## **Development Facilitation Team (DHO) – Review Comments**

**DRB Project No: PR-2019-003169 Date: 10/11/2023 Agenda Item:8 Zone Atlas Page: L-10**

### **Application For: SD-2023-00132 – PRELIMINARY PLAT (DHO)**

DRB Project Number: 2019-003169  
San Ygnacio and Sage

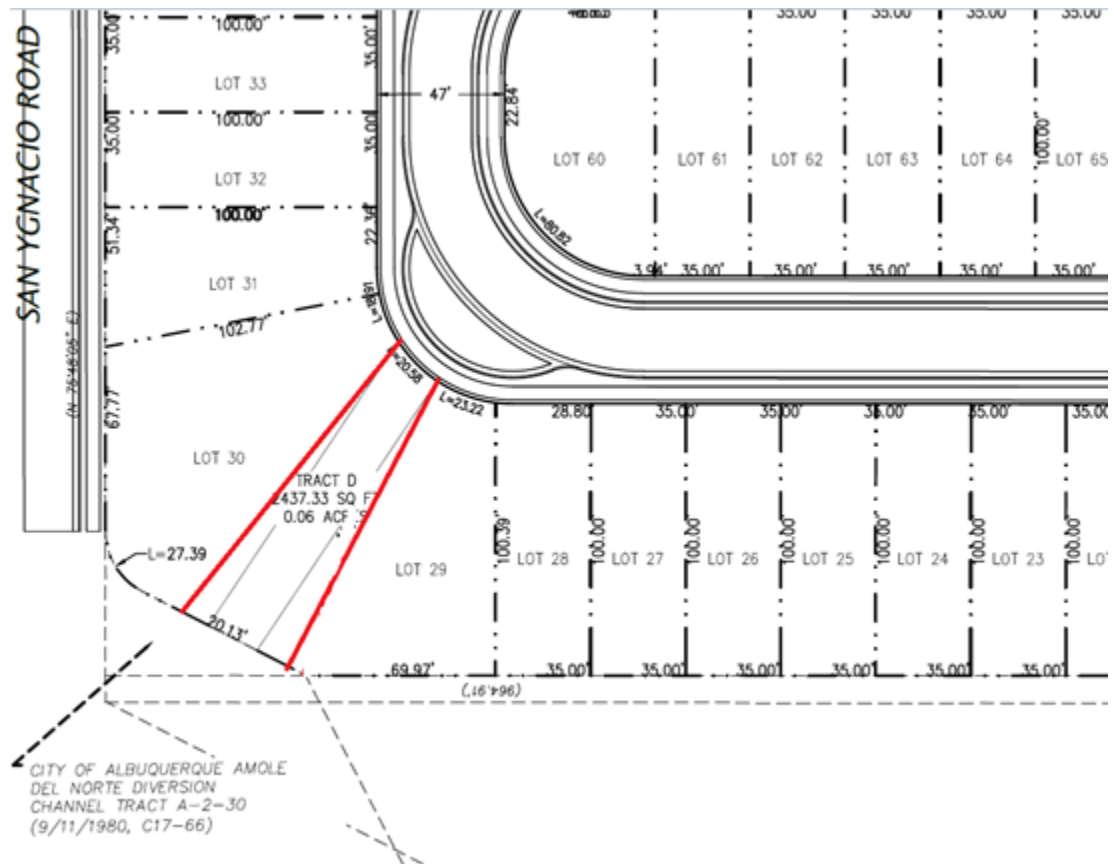
- The applicant has shown a willingness to adjust the pedestrian/bicycle connection to the Amole Diversion Channel. This is to help overcome long block lengths. The following diagram was sent to the applicant and it is requested that this minor change be made to the plat.
